# CITY OF ALBUQUERQUE

**RE: 6105 Little Joe Dr NW**  
**Grading and Drainage Plan**  
**Engineer's Stamp Date: 11/03/18**  
**Hydrology File: E10D054**

Based upon the information provided in your submittal received 11/05/18, the Grading and Drainage Plan is approved for Building Permit.

ENGINEER'S SEAL	LOT 17, BLOCK 7A VOLCANO CLIFFS UNIT 3	DRAWN BY DEM
DAVID SOULE 14522 PROFESSIONAL ENGINEER	GRADING AND DRAINAGE PLAN	DATE 11-1-18
11/3/18	Rio Grande Engineering 1608 CENTRAL AVENUE SE SUITE 201 ALBUQUERQUE, NM 87106 (505) 972-0899	SHEET # C1
DAVID SOULE P.E. #14522		JOB #

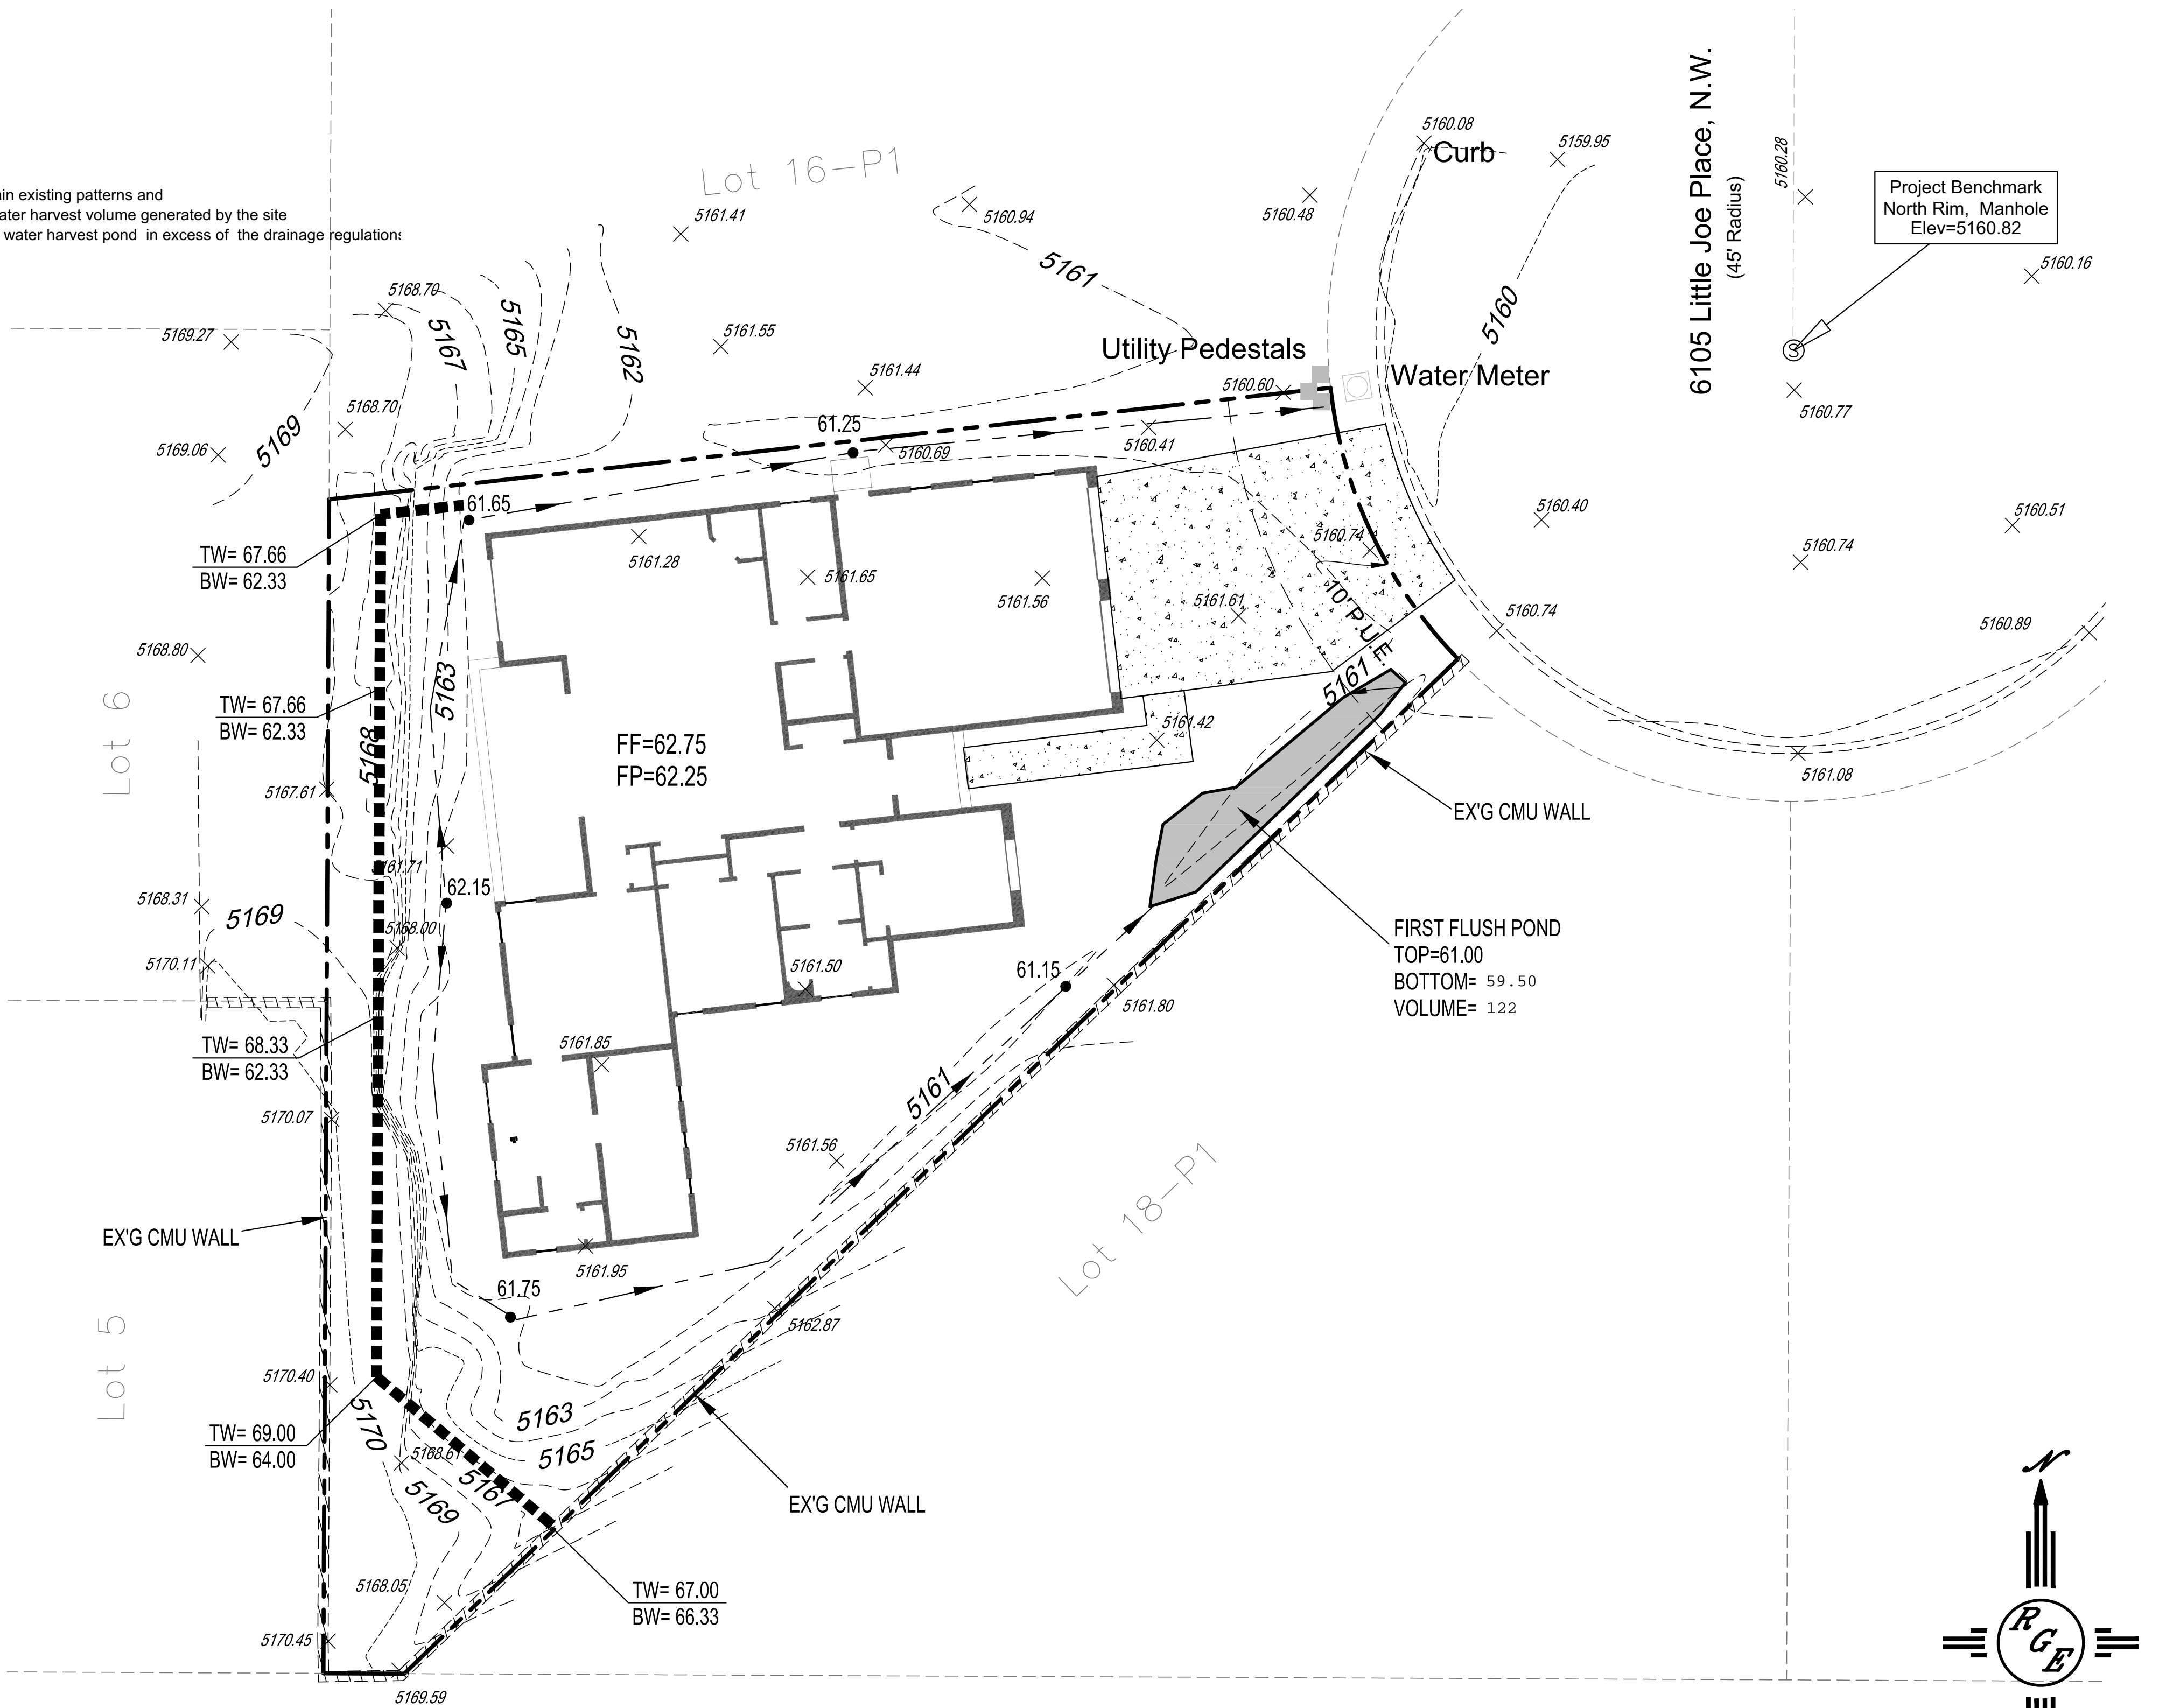
Once the grading is complete, a pad certification will be required prior to release of Building Permit. Please attach a copy of this approved plan in the construction sets for Building Permit processing along with a copy of this letter and the pad certification approval letter.

Prior to approval in support of Permanent Release of Occupancy by Hydrology, Engineer Certification per the DPM checklist will be required and a formal Elevation Certificate needs to be submitted to Hydrology.
